SERVICE BULLETIN REVISION NOTICE

ENGINE — ROTOR AND STATOR ASSEMBLY — PROVIDE NEW SELECTONE 2ND STAGE HIGH PRESSURE TURBINE (HPT) RESTAGGERED BLADES

Turbojet Engine Service Bulletin No. V2500-ENG-72-0575 Revision No. 1 dated December 10, 2020.

To corrrect PN 2A4520 to PN 2A4250.

LOCATION OF 2ND STAGE HPT BLADE FIGURE 2

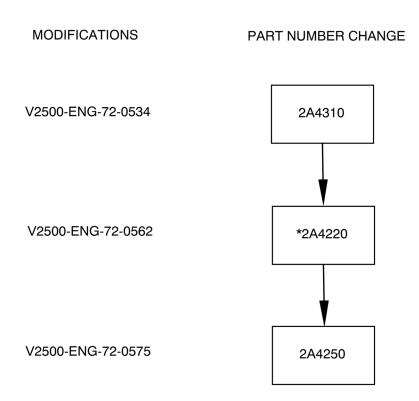
REPLACE THE STAGE 2 HPT BLADE WITH THE APPLICABLE NEW STAGE 2 HPT BLADE ASSEMBLY

- 1. Assembly Instructions
 - A. Install PN 2A4422 Stage 2 HPT Blades Assemblies (72 off) by the approved procedure given in Reference 6, Chapter/Section 72-45-30, Assembly. See Figure 1.

FAMILY TREE - 2ND STAGE HPT ROTOR AND STATOR ASSEMBLY REFERENCE CATALOG SEQUENCE NO. 72-45-00, FIGURE 01, ITEM 010 CHART A

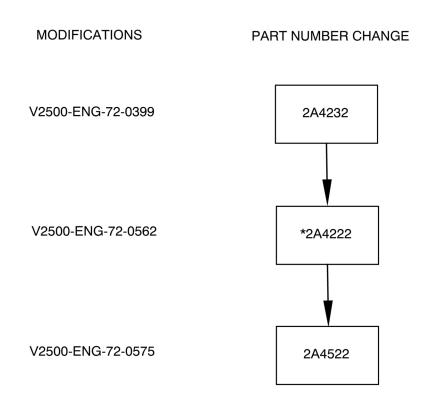
- (1) Use the procedure given in Reference 7, Chapter/Section 70-09-00, Marking of Parts.
 - (2) Mark the new part number, 2A4250, adjacent to the old part number, 2A4220.

FAMILY TREE - 2ND STAGE HPT ROTOR REFERENCE CATALOG SEQUENCE NO. 72-45-30, FIGURE 01, ITEM 010 CHART B

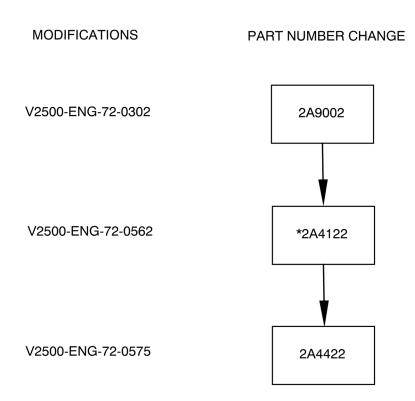
- B. Identify the Stage 2 Turbine Rotor Assembly by the procedure given in Reference 7, Chapter/Section 70-09-00, Marking of Parts.
 - (1) Mark the new part number, 2A4522, adjacent to the old part number, 2A4222.
